MEMORANDUM

RE: Glendale Condominiums Site Plan
Sanitary Sewer Capacity Analysis
File No. SP13-010

Figure 1 – Sanitary Sewer Map

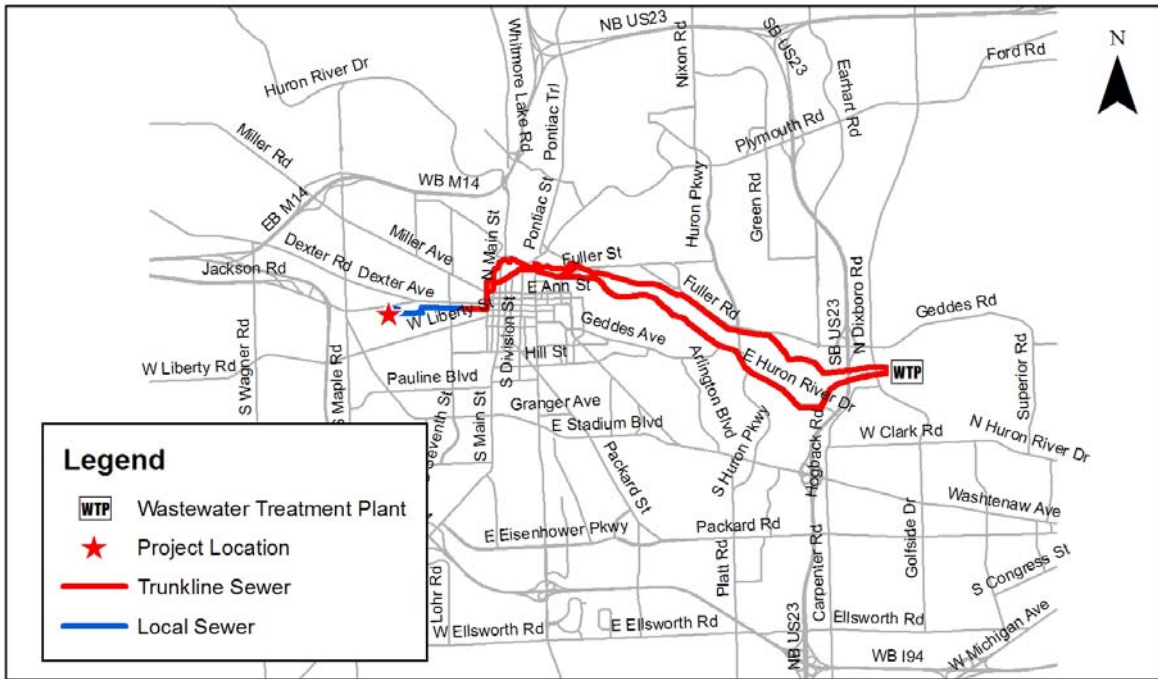
Trunkline Sewer System: Capacity constraints during wet weather events have been identified in the trunkline sewers downstream from this development. Therefore, in accordance with the Development Sewage Flow Offset Mitigation Program, footing drains must be disconnected to offset the proposed flow generated by this development (as well as a 20% system recovery factor). These footing drain disconnections must be performed within the Liberty-Washington or High Level sewersheds upstream of where the development flows connect to the High Level trunkline (intersection of First Street and Washington Street; MH ID 71-70467). **This condition shall be included in the Site Development Agreement for this project.**

The proposed development is located at the northwest corner of Glendale Drive and Charlton Avenue within the Liberty-Washington sewershed. Figure 1 shows a map of the downstream sanitary sewer system based on the proposed connection to the City's existing sanitary sewer system at the intersection of Glendale Drive and Abbott Avenue.

As indicated in Table 1, capacity constraints during wet weather events have been identified in the trunkline sewers downstream from this development. Therefore, in accordance with the Development Sewage Flow Offset Mitigation Program, footing drains must be disconnected to offset the proposed flow generated by this development (as well as a 20% system recovery factor). These footing drain disconnections must be performed within the Liberty-Washington or High Level sewersheds upstream of where the development flows connect to the High Level trunkline (intersection of First Street and Washington Street; MH ID 71-70467). This condition shall be included in the Site Development Agreement for this project.

Figure 2 – Local Sewer System Profile and Modeling Results

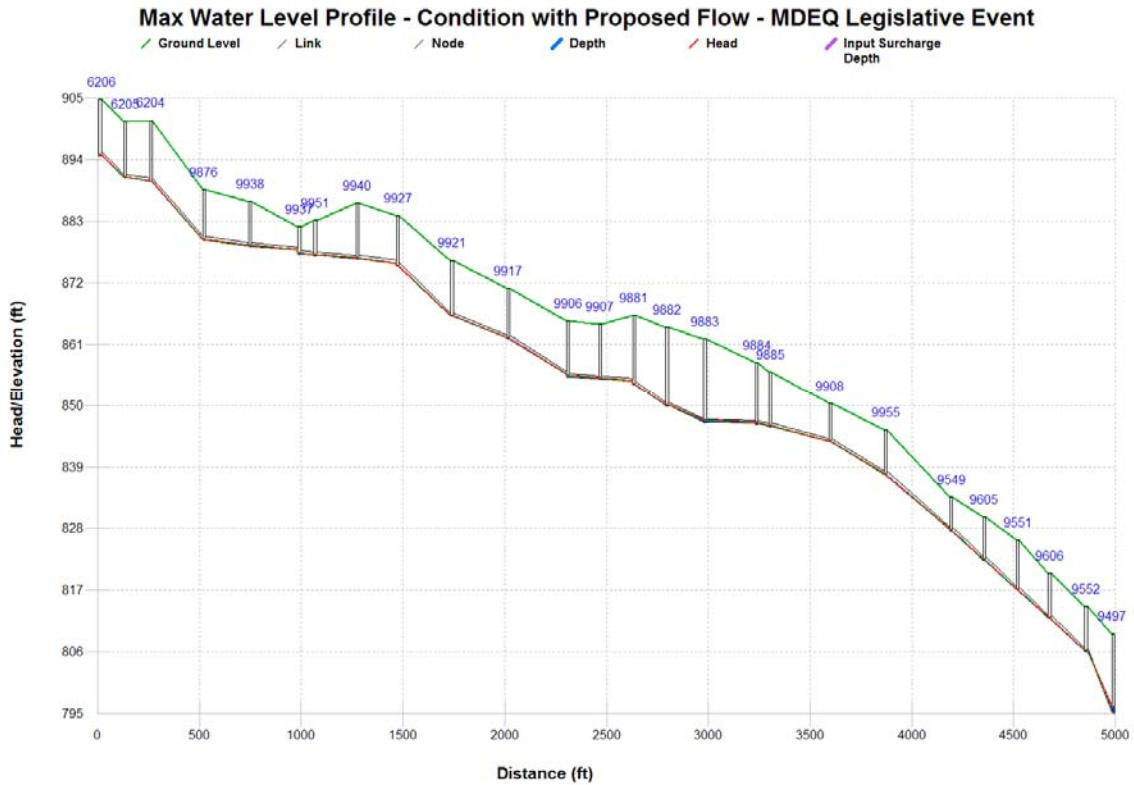
Local Sewer System: Results from the hydraulic modeling indicate sufficient capacity exists in the downstream local sanitary sewer system to support the proposed development.

For the local sewer system, sufficient capacity exists to support the additional flows generated by this development. Figure 2 below shows the pipe profile and modeled hydraulic gradient level for the local sewer system with the additional flow proposed by this development.
